Hi Lox Sender support arm rework.
10/2001 and later.

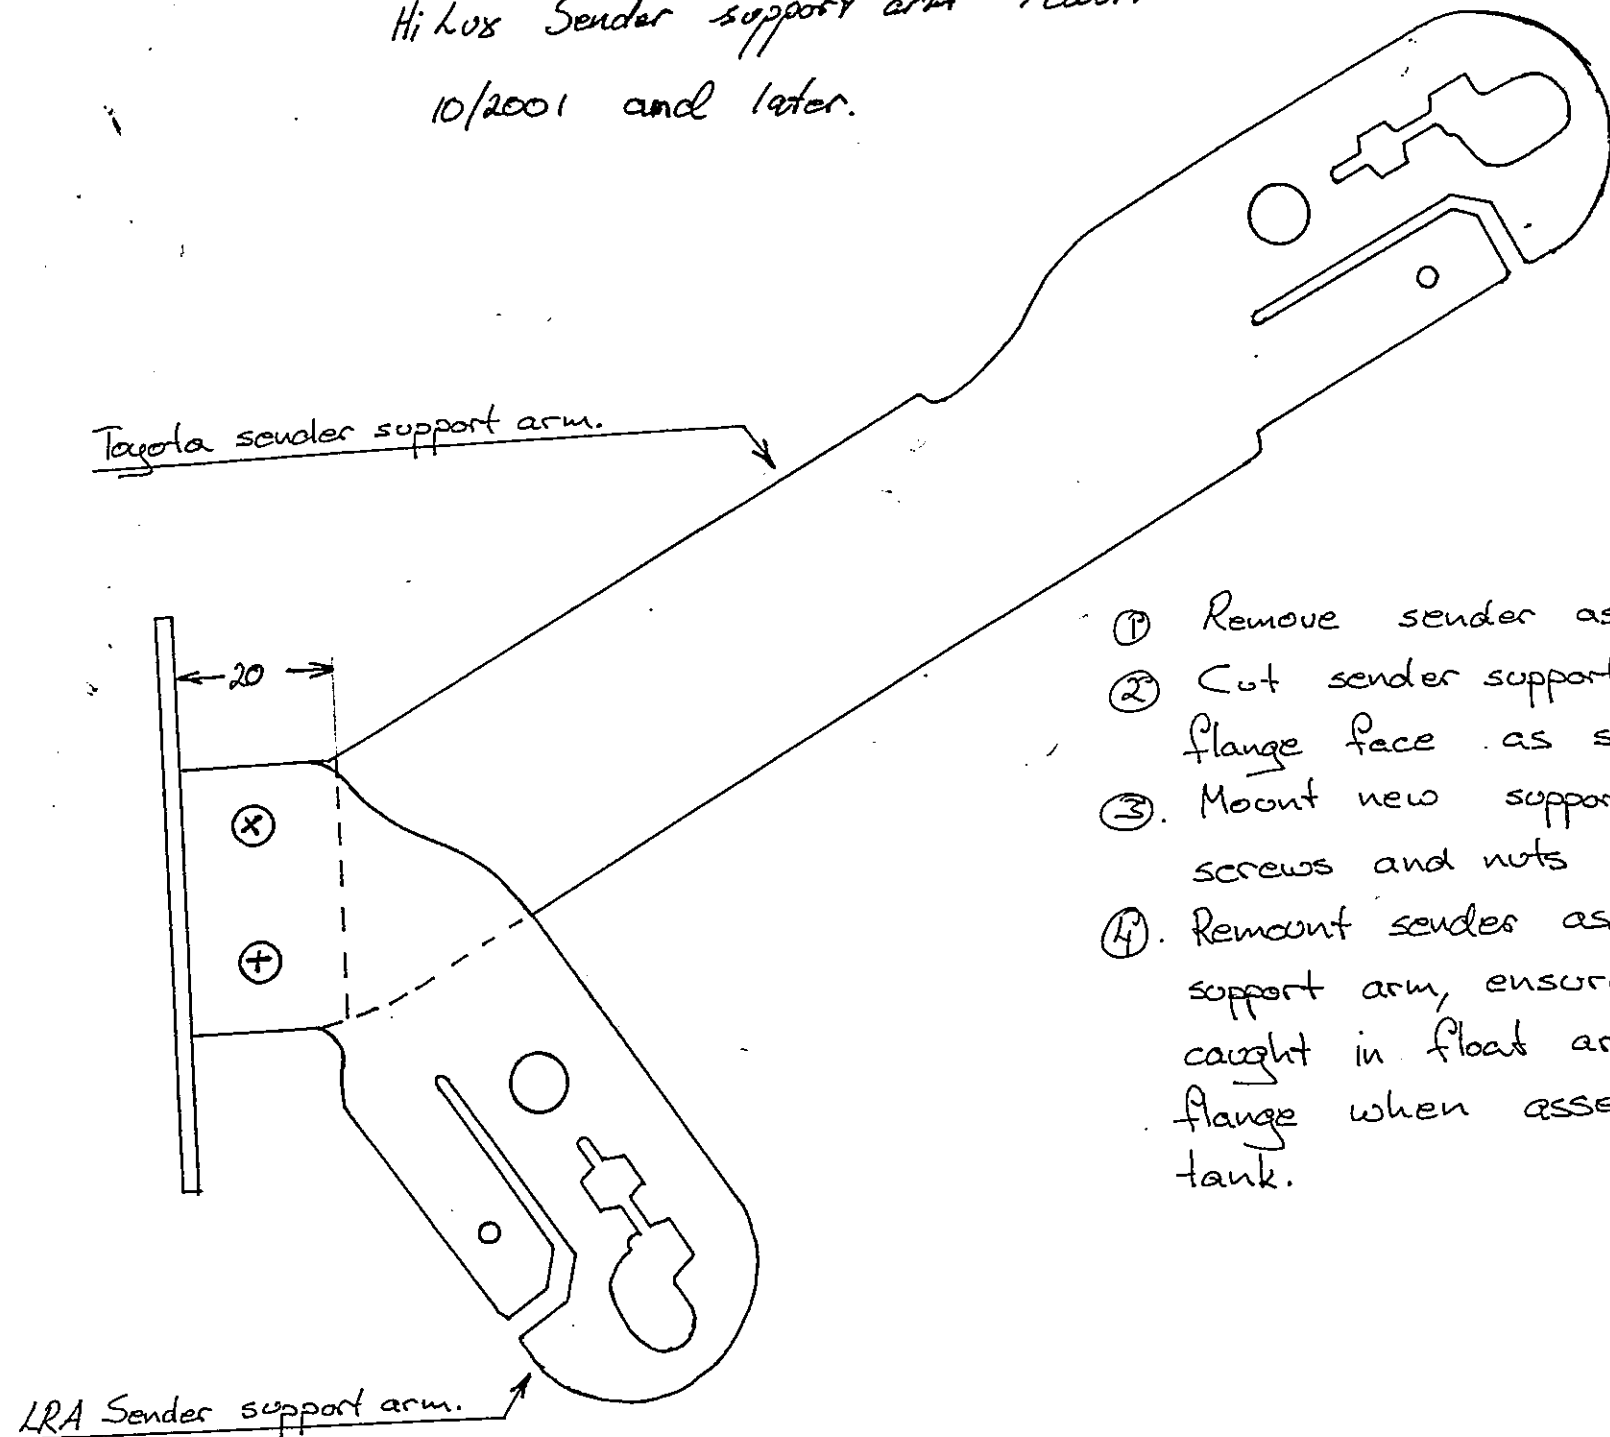
- ① Remove sender assembly from support.
- ② Cut sender support arm 20 mm from flange face as shown.
- ③ Mount new support arm using 145x10 screws and nuts provided.
- ④ Remount sender assembly to new support arm, ensure wires will not get caught in float arm or jammed under flange when assembly is fitted into tank.
